Suggested spot improvements:

240th Street at 102nd Ave.

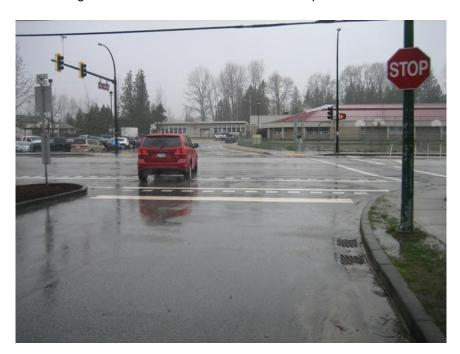
- 351 Signage along MUP 240th St. between Hill Ave and 104th Ave.:
  - o wrong sign was installed on 103 Ave at 240th Street.

Placement of "right turn yield to cyclists and pedestrians bi-directional" should be immediately along the roadway in field of vision of drivers, not on the other side of multi-use pathway. See photos below for comparison.
